JRPP No:	2011SYE060
DA No:	DA 163/11
PROPOSED DEVELOPMENT:	Demolition of existing 7 storey commercial building and construction of 16 storey mixed use development at 619 Pacific Highway, St Leonards
APPLICANT:	Duppa Pty Ltd
REPORT BY:	George Youhanna, Executive Planner North Sydney Council

Addendum Report

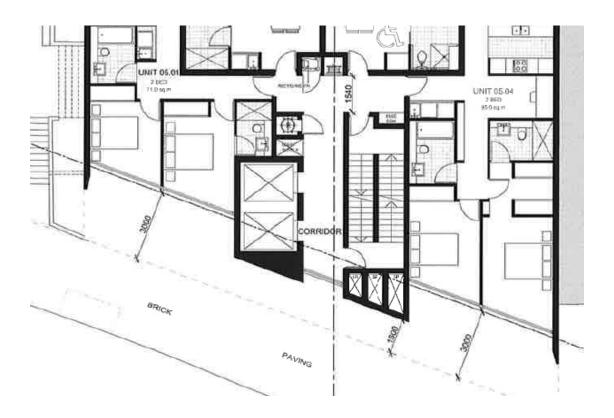
The Panel's request for the application to be amended in order to comply with the 3m setback on the Pacific Highway frontage has necessitated a number of minor amendments the southern facade and the Levels 4-15 floor plans. The key amendments to the application in order to comply with the above podium front setback control were to remove the balconies on Levels 5-15 and move the building alignment back to the 3m setback.

In order to provide articulation to the southern facade, and benefiting from the flexibility in the Panel's resolution, the core is still located within the 3m Pacific Highway setback. To provide further articulation and visual interest to the facade, the vertical architectural blades have been retained on the east and western elevations within the setback. The core and architectural blades are now consistently set back 1.5m from the Pacific Highway.

The amended application fully satisfies the Panel's resolution in relation to providing a 3m above podium setback to the Pacific Highway, including balconies. The following plan shows the setback at Levels 5-15:

As identified by the applicant, only the core and the architectural blades which are both set back 1.5m do not meet the 3.0m setback requirement. It is noted that in order to comply with the Panel's resolution, minor internal reconfiguration has been required, including the following:

- Mirror reversing the lift and fire stair locations
- Increasing the minimum Pacific Highway setback of the core to 1.5m, from approximately 0.8m.
- Minor reduction in the size of the 1 bedroom units from 52m² to 51m² due to the relocated recycling bin and services (fire hose) location.
- Internal reconfiguration of all units

These modifications are necessary in order to comply with the 3m setback requirement and do not adversely affect the amenity of the units.
